Docket No. 52-010

**Subject: Response to Portion of NRC Request for Additional Information
Letter Nos. 54 and 100 Related to ESBWR Design Certification
Application – Radioactive Waste Management Systems – RAI
Numbers 11.2-13S01 and 11.5-37 through 11.5-47**

**Response to Portion of NRC Request for
Additional Information Letter Nos. 54 and 100
Related to ESBWR Design Certification Application**

RAI Numbers 11.2-13S01 and 11.5-37 through 11.5-47

Figure 11.5-1. Location of Radiation Monitors

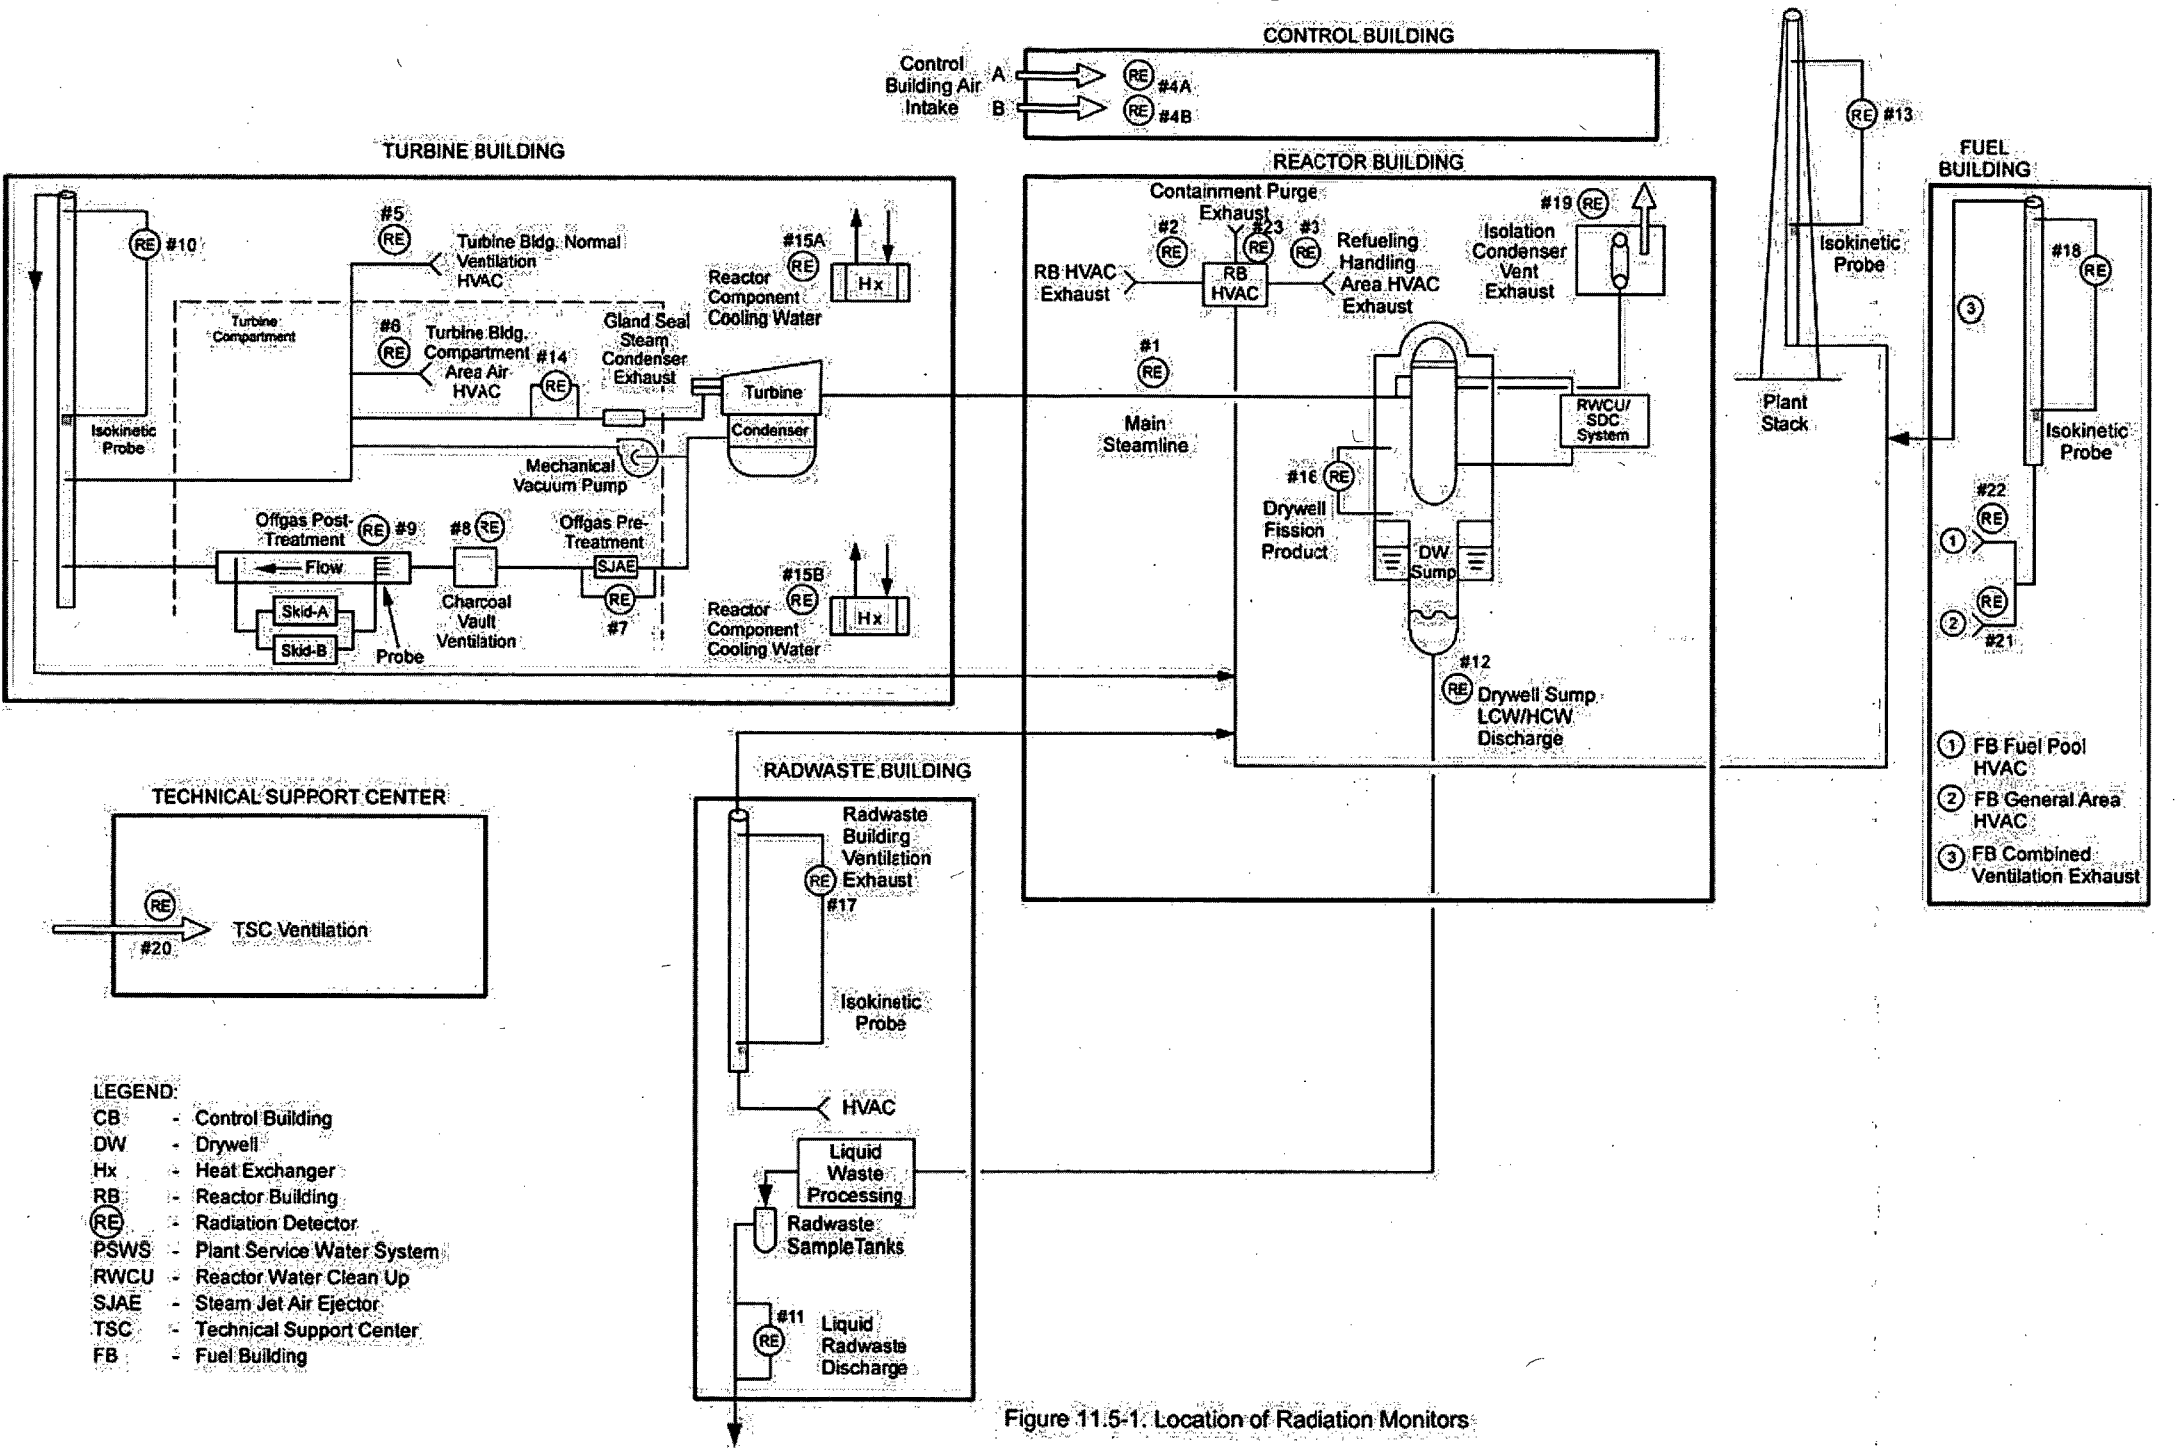
In Revision 3 of the DCD Tier 2, Figure 11.5-1, a place holder for footnote (No. 3) is identified for FB Building Exhaust, but the legend for the footnote is not included in the figure. Accordingly, provide the missing legend in that DCD figure.

DCD Figure 11.5-1 will be revised to add a footnote (No. 3) for Fuel Building Combined Ventilation Exhaust.

DCD Tier 2, Figure 11.5-1 will be revised as noted on the attached markup.
